AMENDMENTS TO THE DRAWINGS:

Figure 17 is amended as described below by presenting replacement figure as attached hereto. An annotated sheet is also submitted for ease of review of the amendments made to Figure 17.

Figure 17

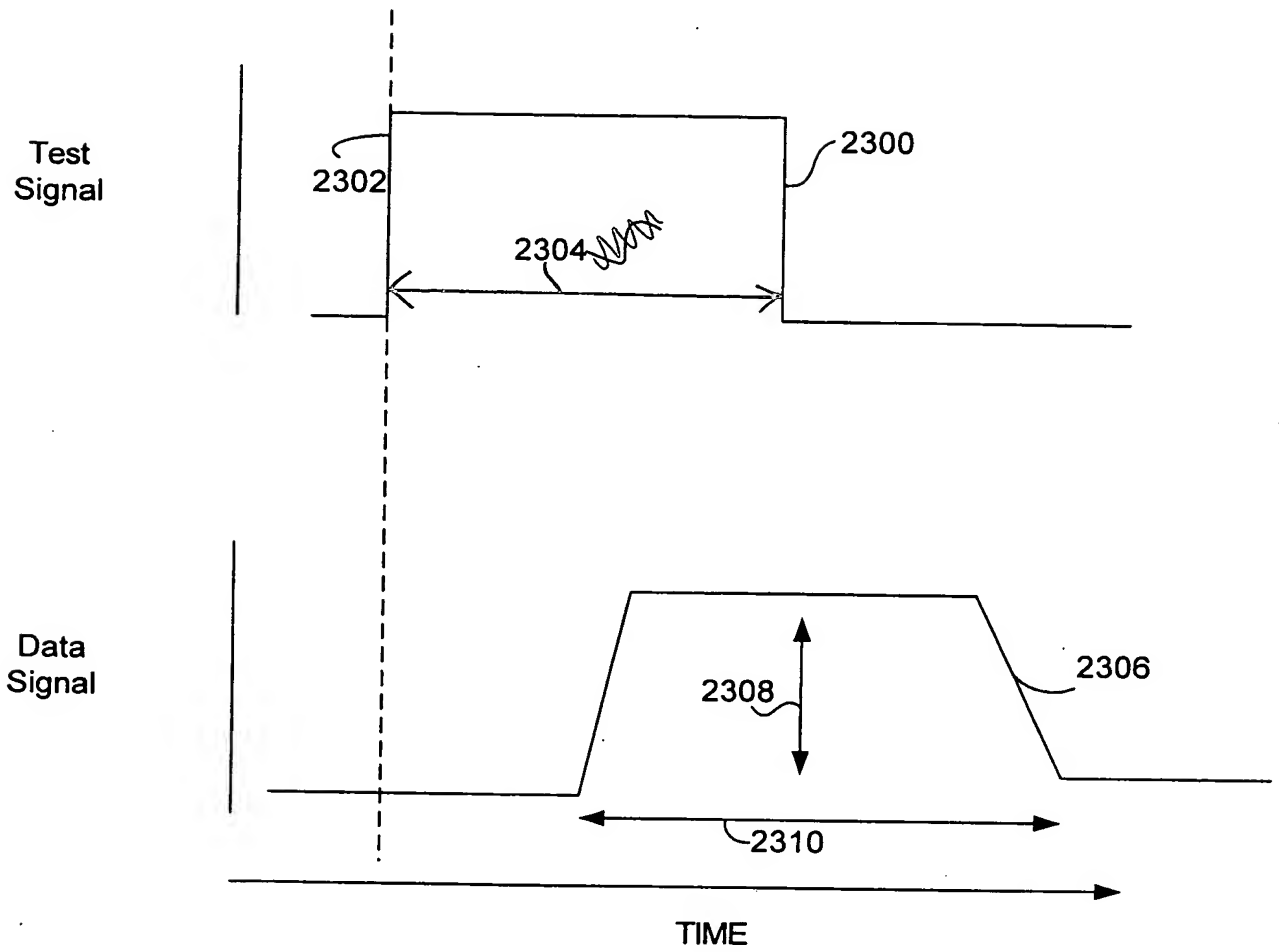
In the Replacement Sheet of Figure 17, element number 2304 has been modified to illustrate a duration of a diagnostic test signal 2300 through a communication channel, as described, for instance, on page 30, paragraph [00132] of the Specification of the present application. No new matter has been added.
